SUBJECT: Permit Modification Request for Section 404 Individual Permit and Section 401 Individual Water Quality Certification for the US-74 Monroe Connector/Bypass in Union and Mecklenburg Counties. STIP R-3329 and STIP R-2559, Division 10, Debit WBS Element 34533.1.TA1 in the amount of \$570.

Reference: US Army Corps of Engineers (USACE) 404 Permit issued May 8, 2015; Action ID: SAW-2009-00876
NC Division of Water Resources (NCDWR) 401 Water Quality Certification Permit issued March 6, 2015; NCDWR Project No. 02-0672 V3

PERMIT DRAWINGS
SHEET 183 OF 267
REVISED: 11/16/2015

PERMIT DRAWINGS
SHEET 213 OF 267
REVISED: 11/9/2015

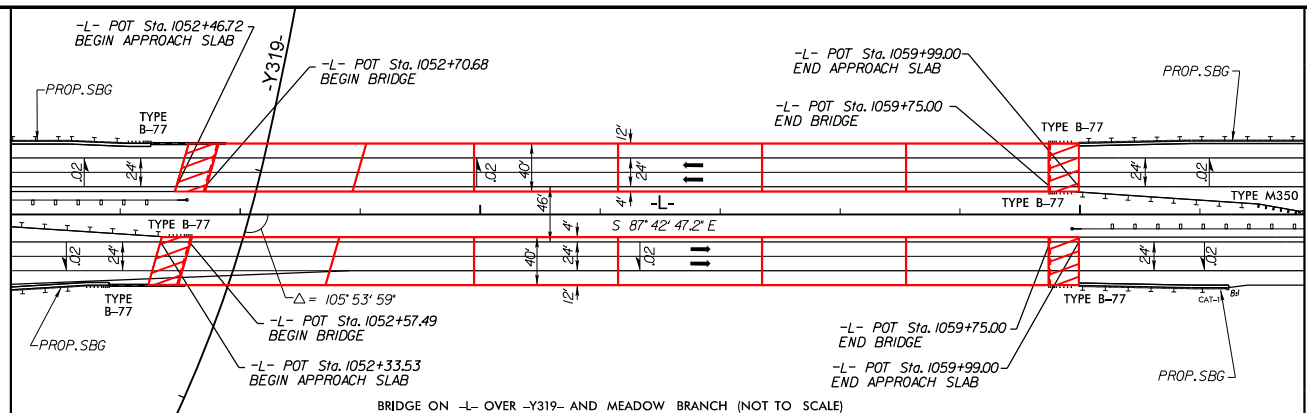
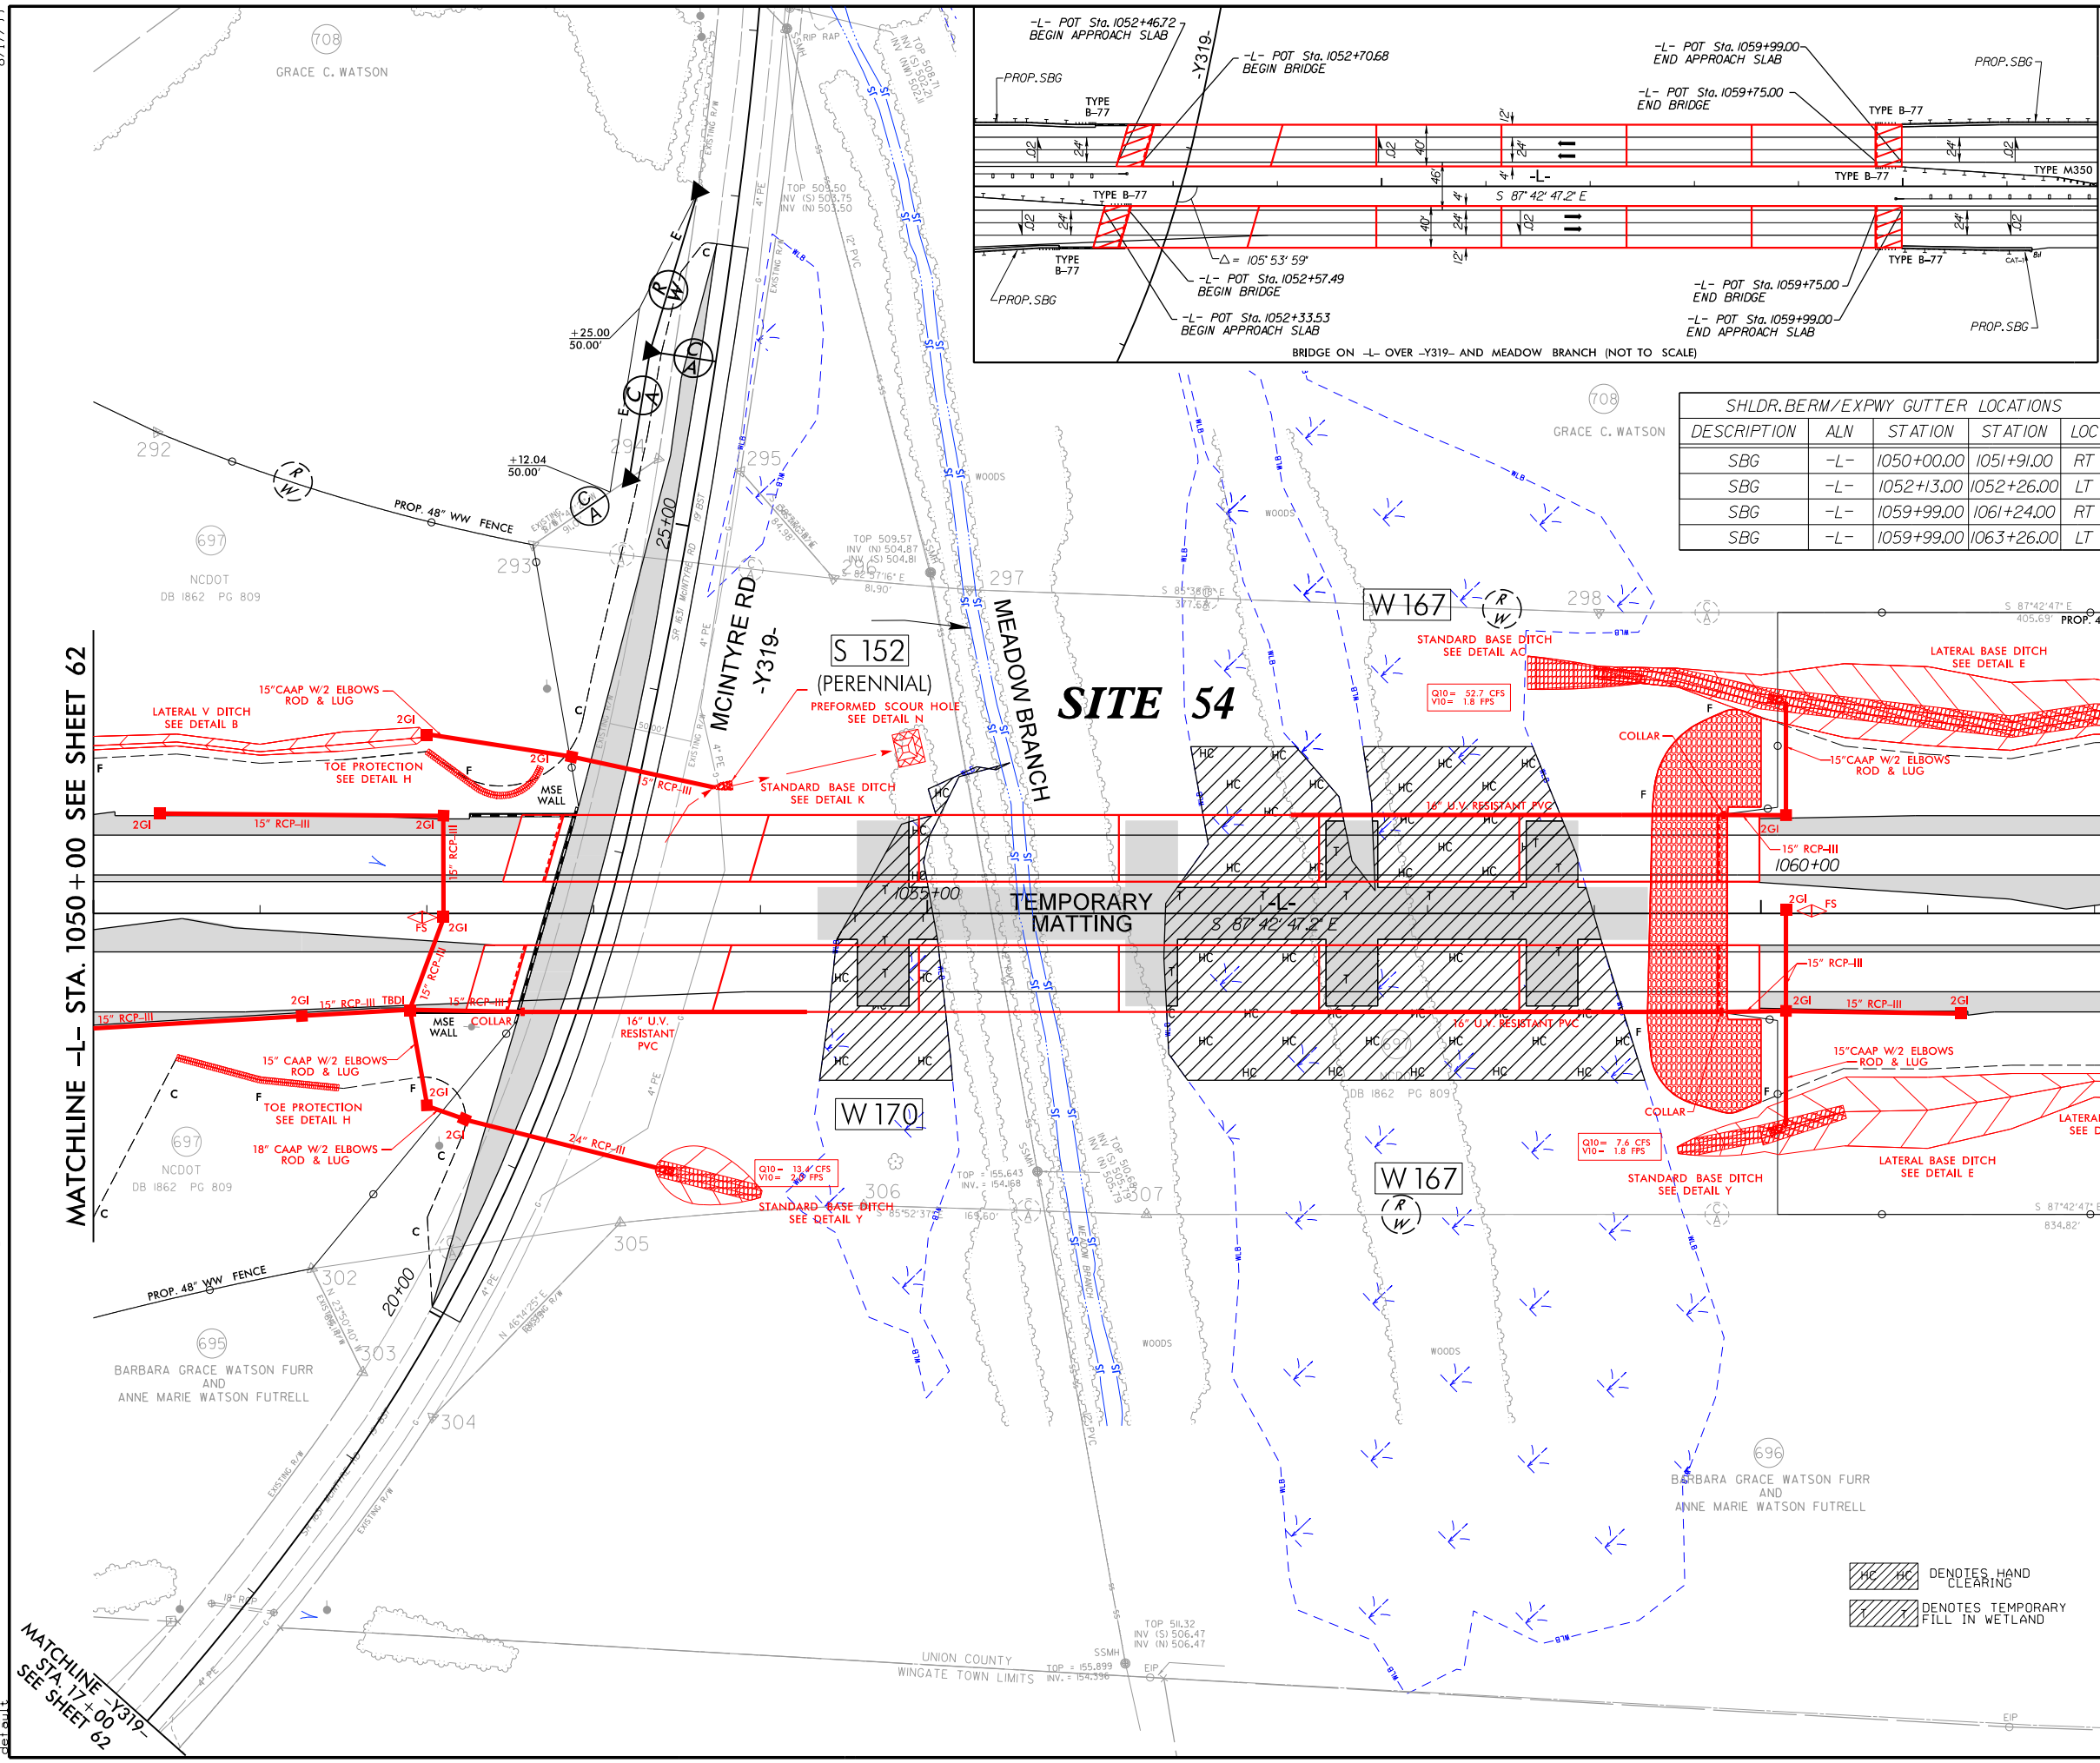
Permit Site 54 (Revised Permit Drawings 213 and 214 of 267):

As noted in our correspondence on October 26, 2015, Site 54 is the crossing of Meadow Branch and the associated high quality wetland. As initially permitted, it was anticipated that it would be necessary to have 2 temporary work pads - along either side of the bridge - with work fingers extending towards the middle. However, taking the bridge design, access, and sensitive environmental conditions into consideration, the bridges can be constructed from a single work pad between the two bridges with the work fingers extending outwards.

This minimization will reduce the temporary impacts by 0.15 acre, from 0.52 to 0.37 acre.

The areas previously impacted by the work pads, will now only be impacted by hand clearing. This increases the hand clearing at Site 54 by 0.15 acre.

| REVISED 11/9/2015 PERMIT DRAWING SHEET 229 OF 267 | | | |

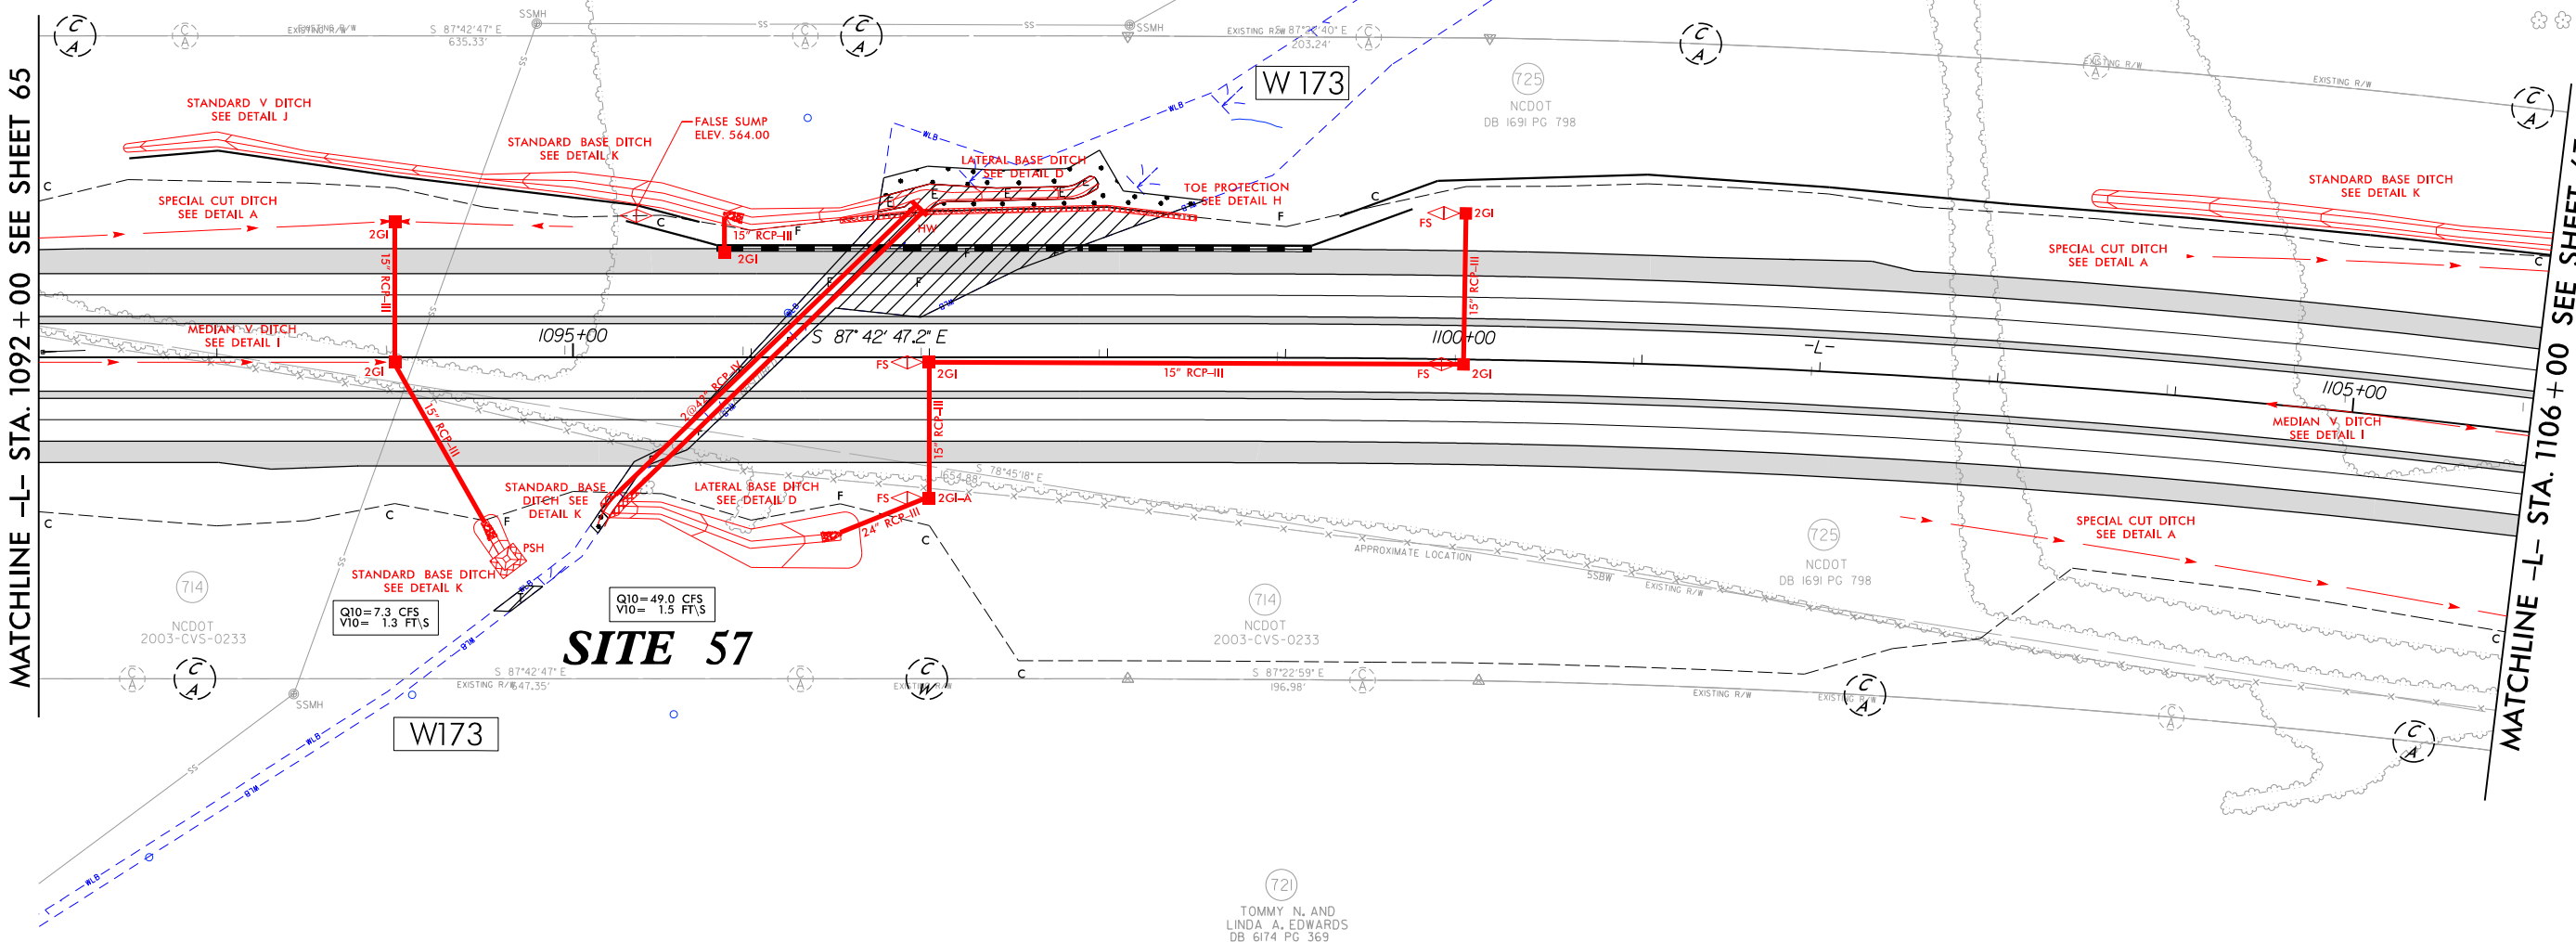
Permit Site 57 (Revised Permit Drawings 229 and 230 of 267).

As you are aware from our correspondence on August 21, 2015, prior to the start of construction, environmental staff re-flagged jurisdictional areas for crews to install orange construction "avoidance" fencing. At the time, Site 57 was an active pasture. At some point between flagging and fencing installation, the flagging was removed. This precipitated several other events eventually resulting in the fill of a section of the Site 57 wetland, not previously authorized for fill.

This resulted in approximately 500 ft² (<0.01 acre) of permanent wetland impacts.

Upon discovery and reporting of the error, the contractor was prepared to remove the fill and return the site to pre-construction conditions. However, after further discussion with Division 10 and the Natural Environment Section, this impact allows for an expedited construction of the adjacent permanent pipe crossing. With this consideration, it was agreed to leave the temporary fill in place, expedite construction of the pipes, and remove the fill and return the area to its natural state.
